6-30126 Pennsylvania Flyer 0-8-0 Whistle Tender Fix

Problem; Air whistle does not sound when the whistle button is pressed on the transformer and/or the whistle is barely audible.

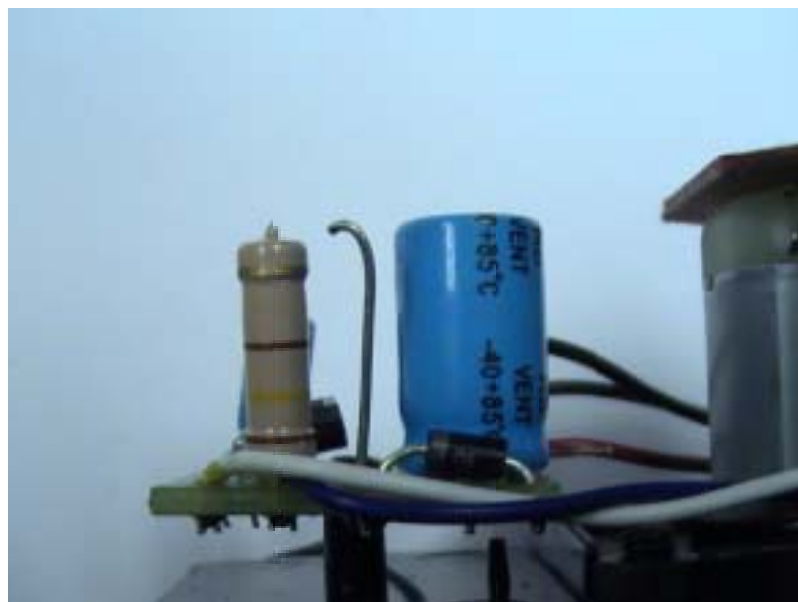
3.) Once the shell is removed locate the largest of the 3 resistors. The reference on the PCB is R3 (but looks like R31).

Solution: Remove R3 resistor from the air whistle PCB assembly.

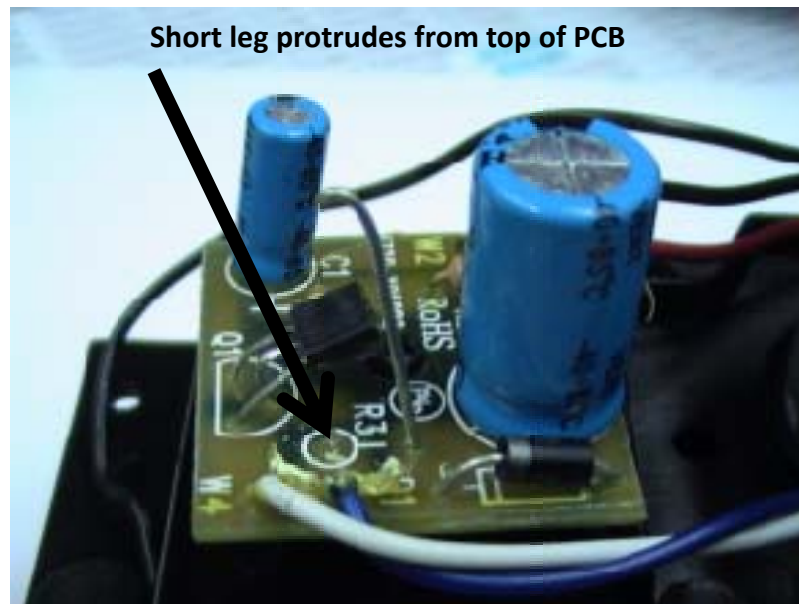
4.) Using a pair of small wire cutters cut the leg off the top of the resistor. (this leg will be used, So do not cut it off the PCB where it is soldered). The photo below illustrates how it looks when cut.

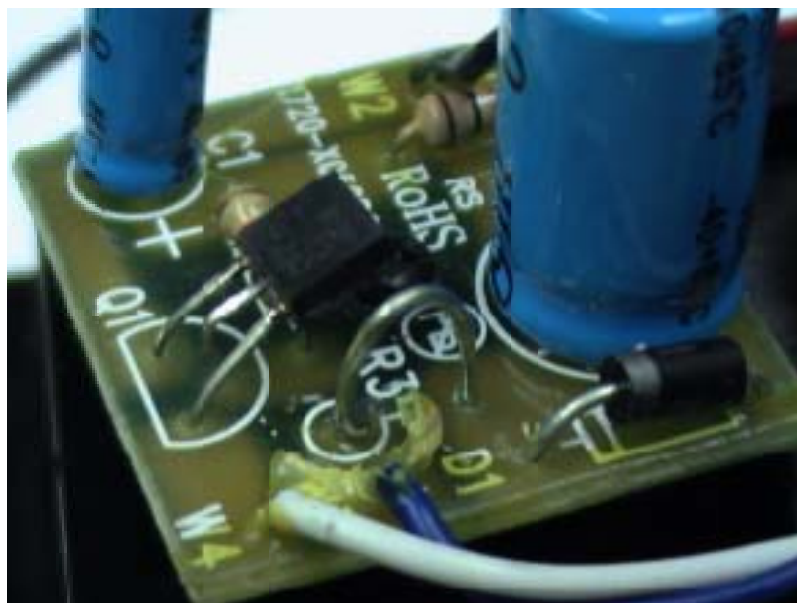
5.) Using small wire cutters cut the resistor at the bottom of its body, where it is soldered to the PCB. The PCB should look like the photo below at this point.

6.) Bend the long resistor leg over and solder the end to the short leg soldered at the base of the resistor. It may be necessary to scrape some of the adhesive away from the solder point, just don't break the wires off doing so! The photo below illustrates the finished repair.
